Litton

October 22, 1987

Subject: 42 CFR Part 84 Revision of Tests and Requirements for
Certification, Respiratory Protective Devices

Figure 4. Sample Breathing Resistance Versus Tidal Volume Loop (P-V Loop)

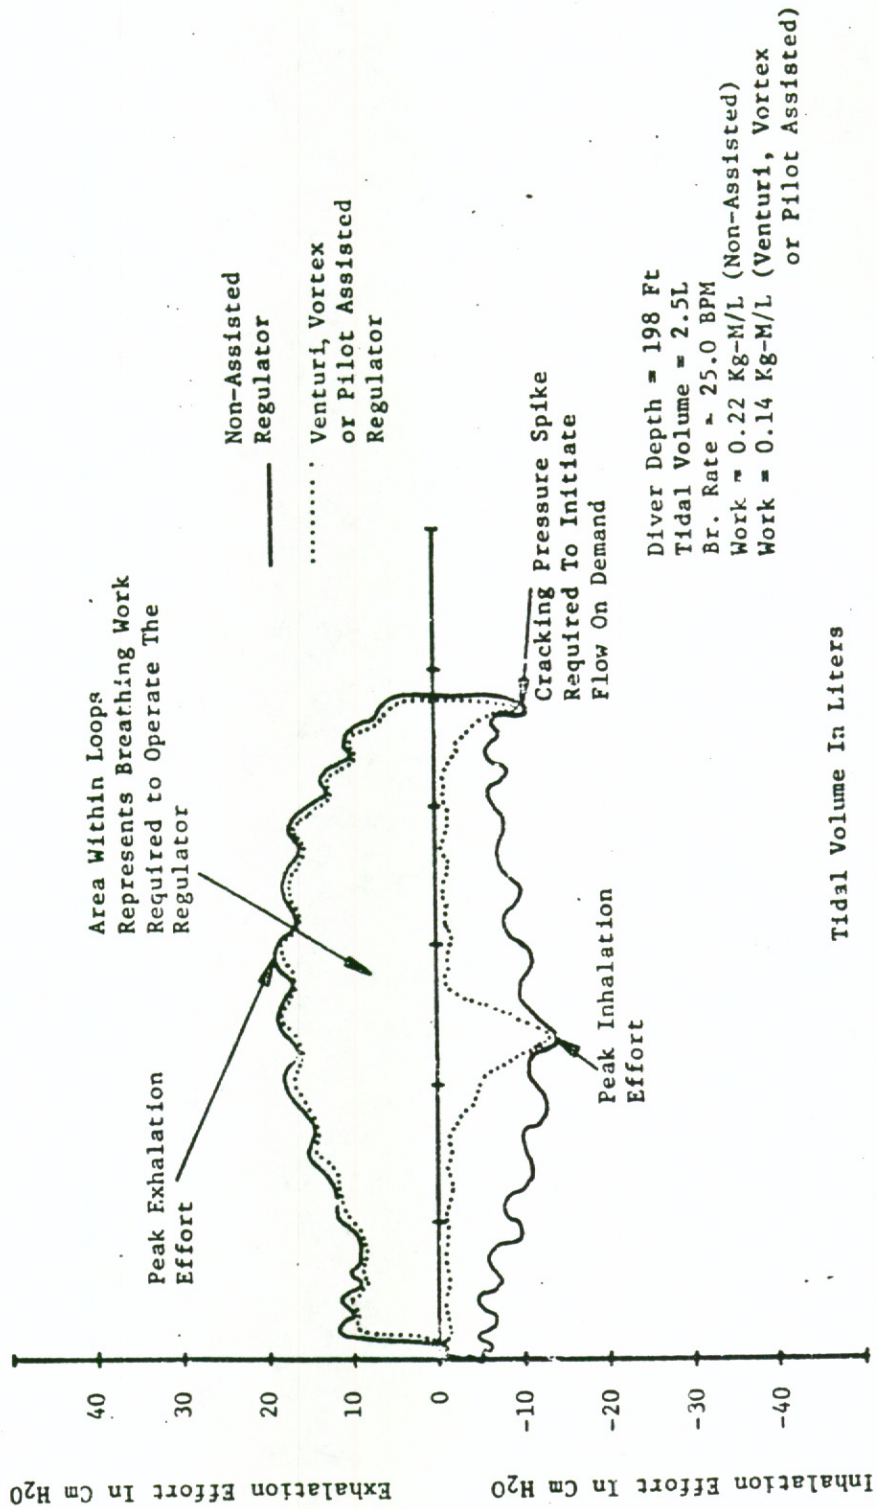
- (2) NIOSH could impose a maximum work of breathing value, similar to the attached Naval report 2-80, page 47 and figure 4 from page 45. The most important properties of an SCBA are protection and work imposed on user. Protection should be kept to a maximum and imposed work to a minimum. Work is determined by making an X-Y plot of flow vs. facepiece pressure. The area inside the loop is a measure of work. NIOSH should specify 0.0 minimum facepiece pressure and maximum work limits.

significantly since this peak inhalation pressure occurs for a much shorter period of time. This fact is illustrated in Figure 4. Work of breathing, defined as the area enclosed within the P-V loop, is seen to be much larger for the non-assisted regulator (solid curve) than the area representing the assisted unit (dotted curve). Consequently, while peak pressures on two different regulators may be identical, the actual respiratory work required from the diver can be significantly different. In addition, how "hard", or "easy" a regulator breathes is a direct function of whether or not the diver has to maintain the peak inhalation and exhalation pressures for the entire breathing cycle.

It was for this reason that breathing work rather than breathing resistance is the more valid approach for setting performance standards.
